DEFIANCE CITY SCHOOLS
Bus Maintenance Garage
Defiance, Ohio

C4-4997

ADDENDUM 1

ITEM NO. 3: Sheet P-101 – Plumbing Plan and Details

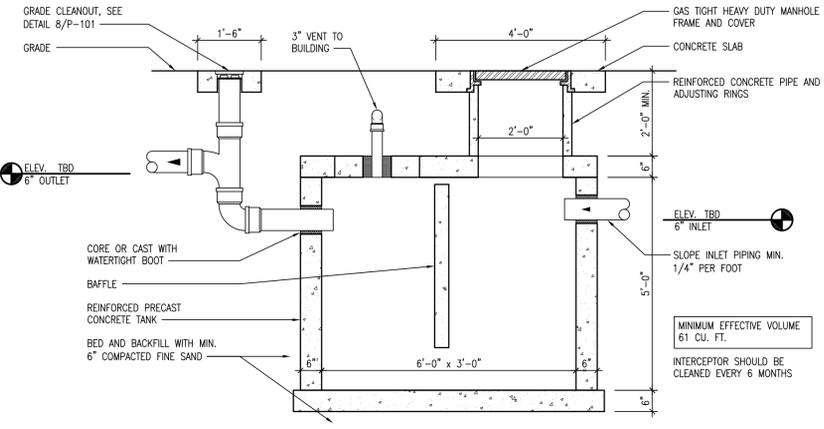
Refer to attached revised Drawing for trench drain venting.

ITEM NO. 4: Sheet P-901 – Plumbing Isometric

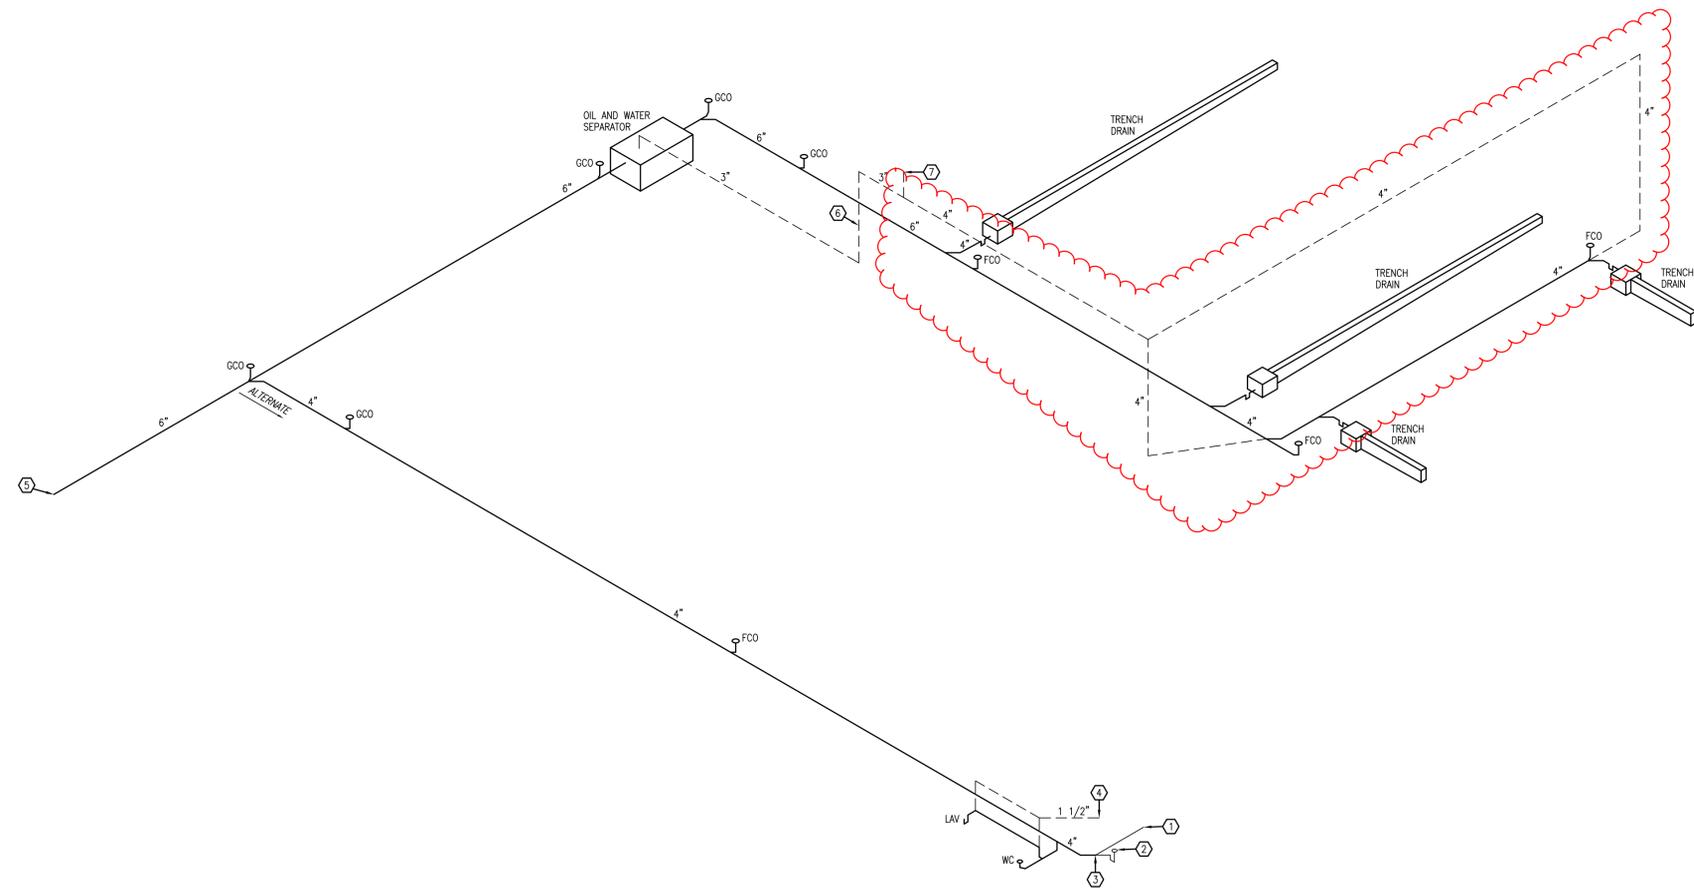
Refer to attached revised Drawing for trench drain traps and venting.
